ALERT SERVICE BULLETIN

No. 55.00.16

SUBJECT: STABILIZER(S)

Improvement of attachment strength for upper and lower fin skids

Figure 1

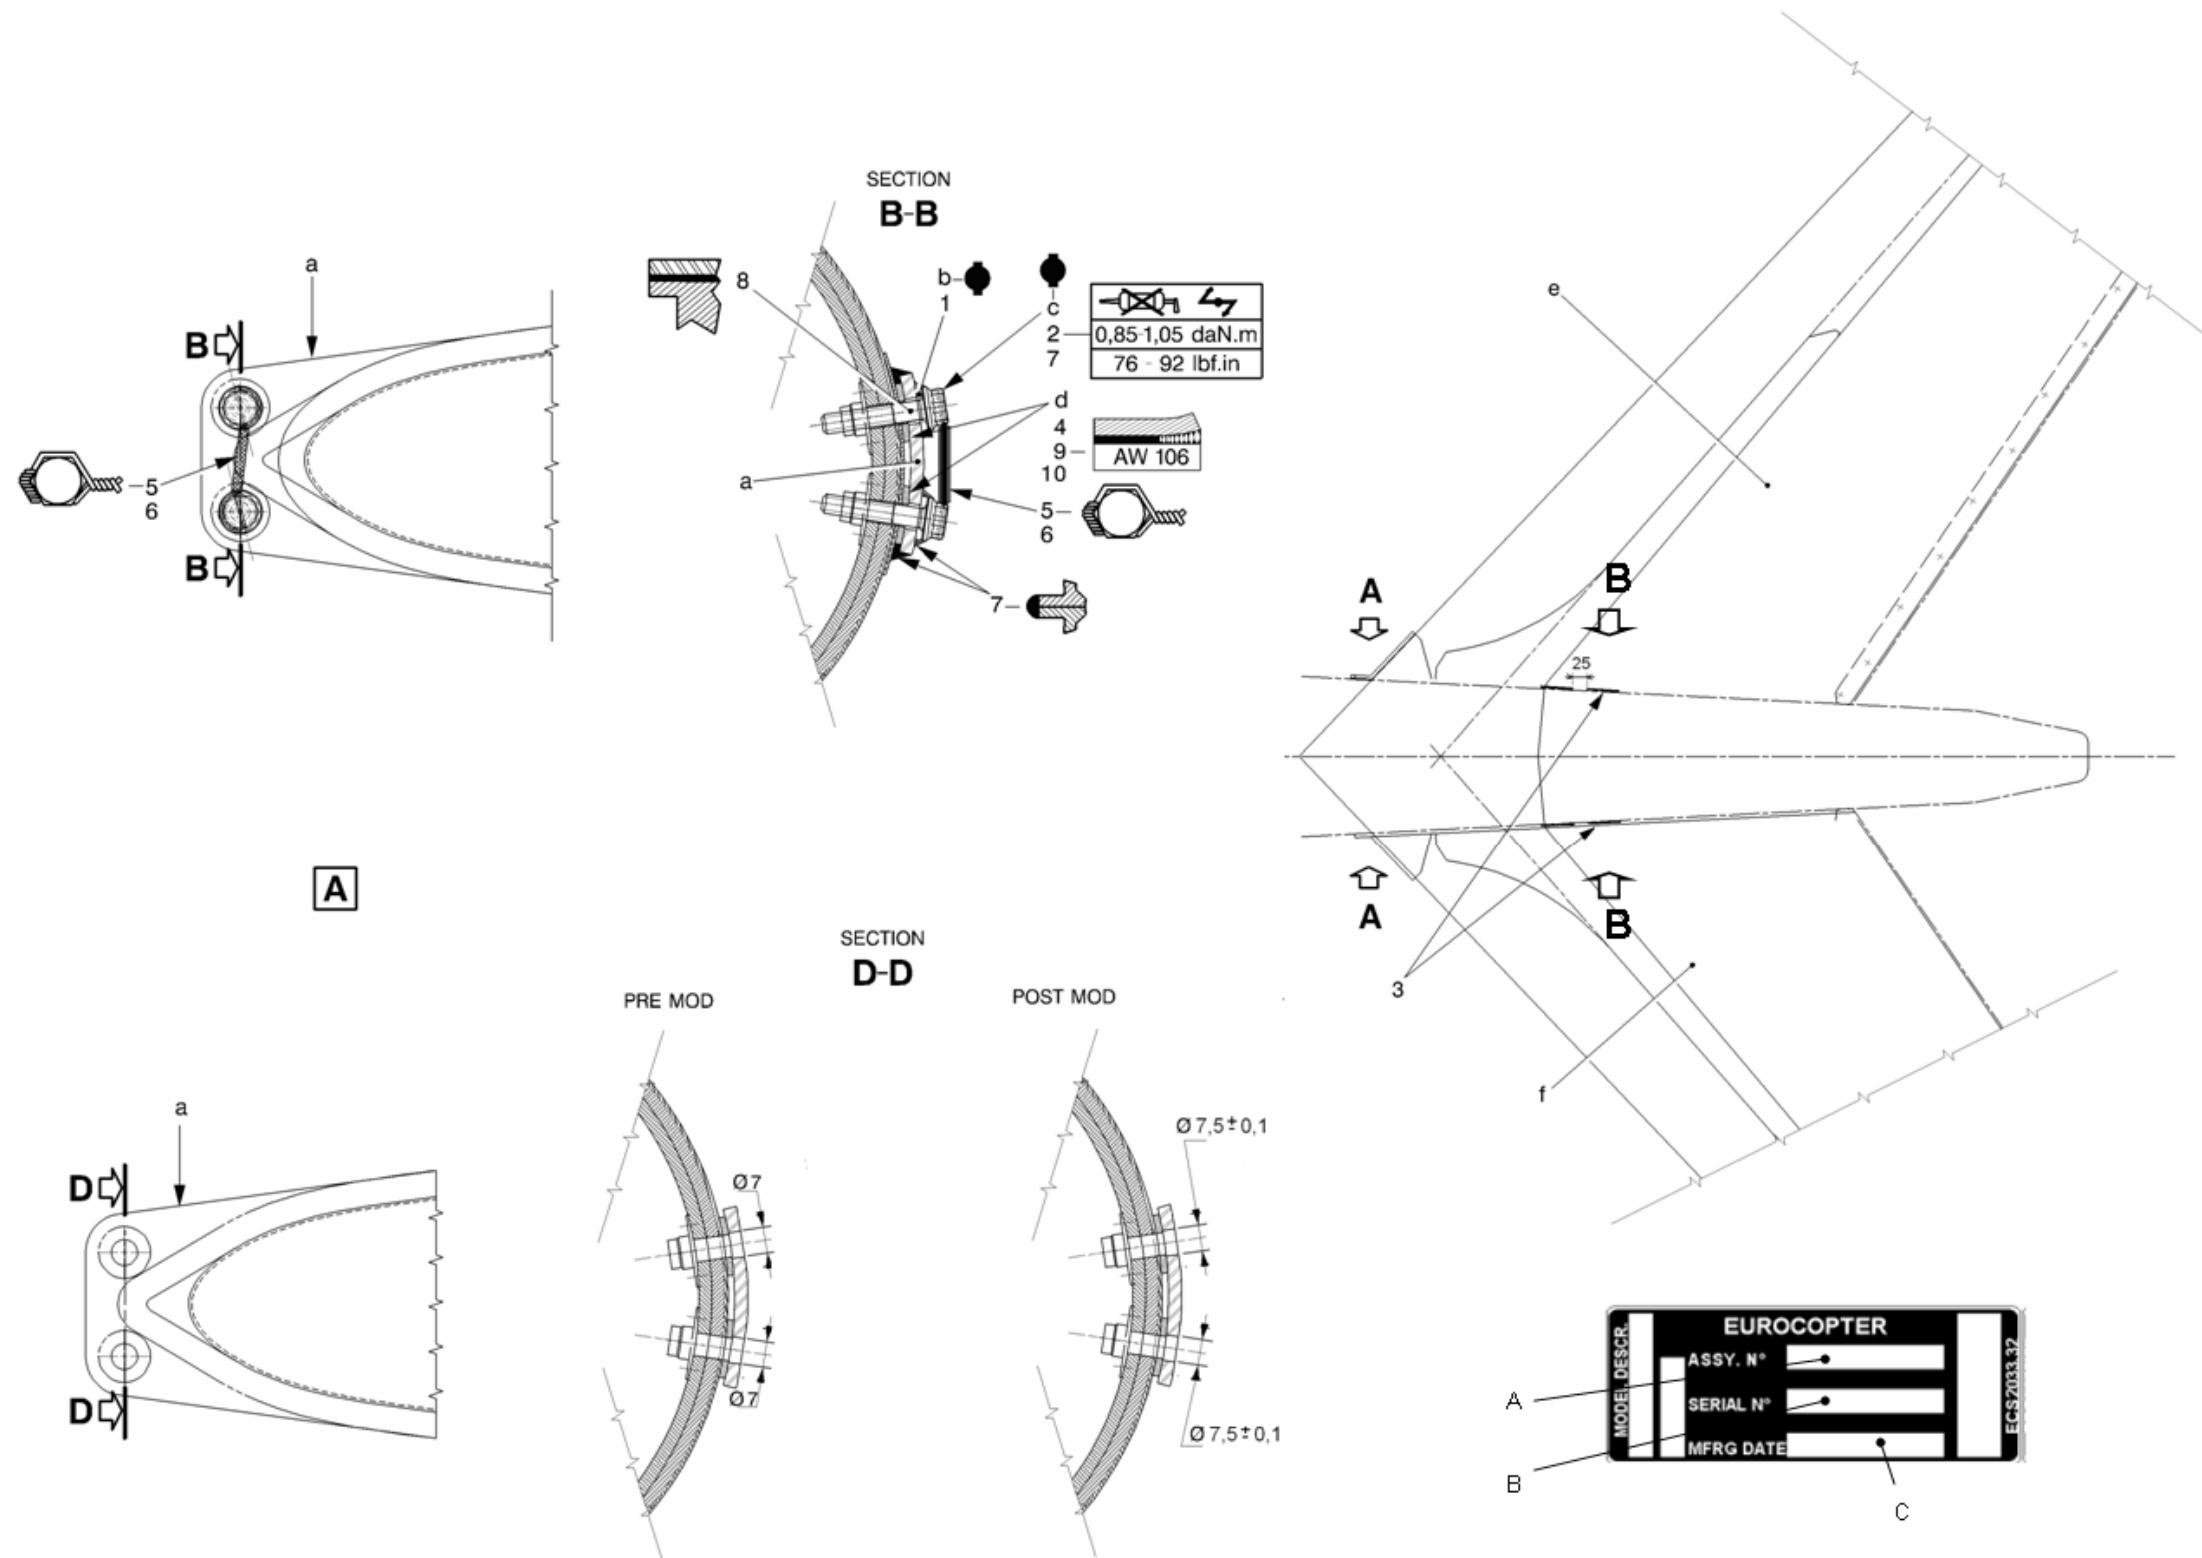
- reducing risks of loaded installation by increasing the diameter of passage holes for bolts on lower and upper fin attachment fittings on tail boom.
- improving fatigue strength of upper and lower fin attachment by replacing bolts P/N: 22126BV060032L with special bolts with higher head P/N: 350A23-4016-20 and replacing washers P/N: 23112AG060LE with special washers P/N: 350A23-4017-22.

- Remove and separate upper fin (e) from lower fin (f) as per Work Card 55.00.00.402 (MET).
- Scrap bolts (c) and washers (b).

2.B.2.b. Modification of lower and upper fittings on work bench (Figure1, Detail A and Section D-D)

- Increase initial diameter of passage holes for bolts in fitting (a) from 7 mm to 7.5 mm + or – 0.1 mm.
- Deburr and carry out protection against corrosion.
- Carry out paint touch up, as required, as per Work Card 20.04.05.101 (MTC).

2.B.2.c. Installation of fins (Figure 1, Detail A and Section B-B)

- Assemble upper fin (e) and lower fin (f) as per Work Card 55.00.00.402 (MET).
- Offer up fin assembly on tail boom.
- Check presence of peel washers (d) installed underneath fitting (a):
 - If peel washers are present (d), check that fitting (a) is properly resting on existing washers (d). Otherwise, remove peel washers (d) and carry out procedure below,

- if no peel washers are present (d) check clearance between fin and skin of tail boom as per Work Card 55.00.00.402 (MET) and should setting be required:

- define thickness of peel washers (4) to be installed as per clearance read,
 - install and bond peel washers (4) on skin of tail boom by means of adhesive (9) and hardener (10) as per Work Card 20.06.02.303 (MTC).

- Loosen TGB attachment bolts TGB in order to facilitate installation of new bolts (2).
- Coat shank of bolts (2) with sealant (8).
- Fit bolts (2) fitted with washer (1).

- Tighten bolts (2) to torque.
- Safety bolts (2) by means of lockwire (5).
- Protect twist of lockwire (5) with a piece of sheath (6).
- apply bead of sealant (7) on periphery of fitting (a) of fin (e or f) and around heads of bolts (2).
